7C Defense Against Common-Mode Failure in Safety-Related, Software-Based I&C Systems

The information in this appendix of the reference ABWR DCD, including all subsections and figures, is incorporated by reference with the following departures.

STD DEP T1 3.4-1 (Figure 7C-1)

Figure 7C-1 Implementation of Additional Diversity in SSLC to Mitigate Effects of Common-Mode Failures

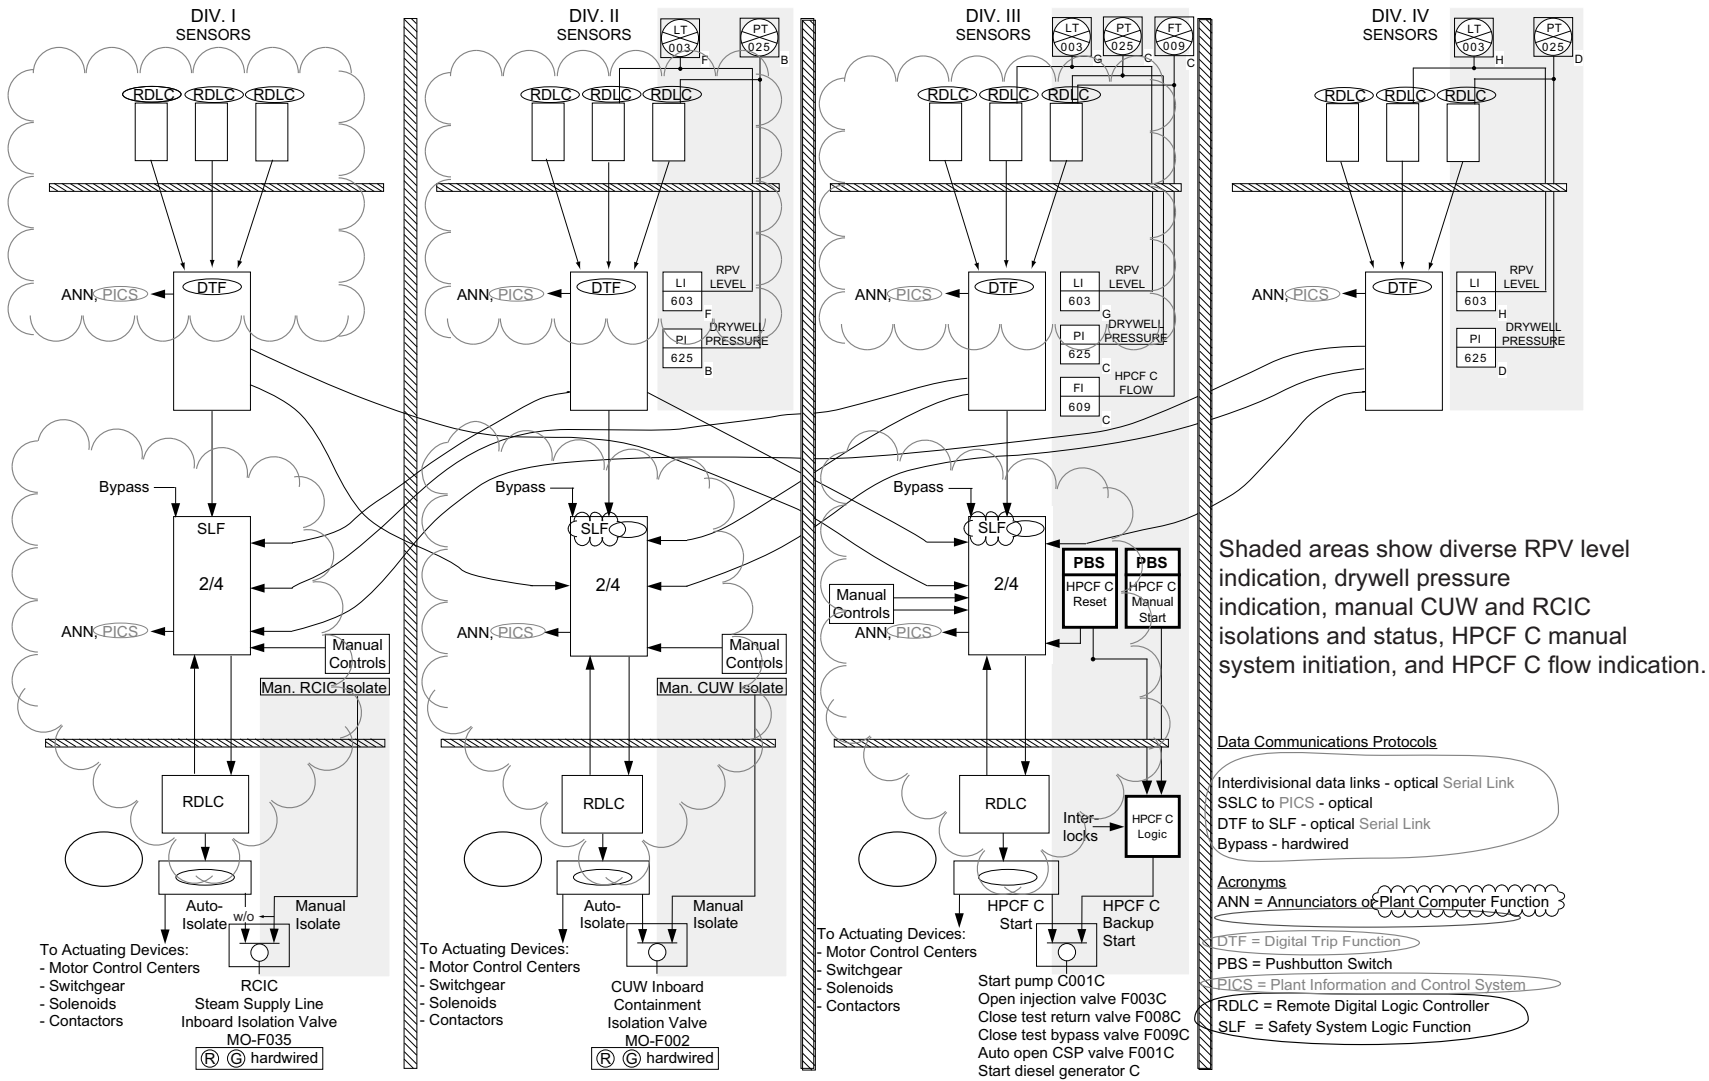
To maintain protection system defense-in-depth in the presence of a postulated worst-case event (i.e., undetected, 4-division common mode failure of all communications or logic processing functions in conjunction with a large break LOCA), diversity is provided in the form of hardwired backup of reactor trip, diverse display of important process parameters, defense-in-depth arrangement of equipment, and other equipment diversity as outlined below (many of these features were included in the original protection system design; refer to Figure 7C-1 for details of how those additional diverse features, added as a result of the CMF analyses discussed in the previous section, have been implemented). Note that diverse equipment can be in the form of digital or non-digital devices as long as these devices are not subject to the same common mode failure as the primary protection system components:

- (2) Defense-in-depth configuration:
 - (a) Fail-safe RPS and fail-as-is ESF in separate processing channels
 - (b) Control systems are independent of RPS and ESF in separate ~~triplicated processing network~~ communication functions using diverse hardware and software from the ~~Essential Multiplexing System~~ Essential Communication Function (ECF) network
- (3) Equipment diversity
 - (d) HPCF manual start in loop C (Division III) is implemented in equipment that is diverse from the automatic start function. All interconnections are hardwired and control and interlock logic is provided in the form of either

discrete logic gates or programmable logic that is diverse from the automatic start logic. The signal path of the manual logic is independent from that of the automatic logic up to the actuated device drivers (e.g., motor control centers or switchgear). The manual start function is not implemented in the automatic logic; ~~however, the logic reset switch is common to both the automatic and manual logic.~~ In addition to the manual start function, which performs all necessary control actions as a substitute for automatic start, other supporting hardwired functions are provided in loop C as follows:

- (v) Remote shutdown system (~~analog~~ diverse, hardwired) provides shutdown cooling functions and continuous local display of monitored process parameters.
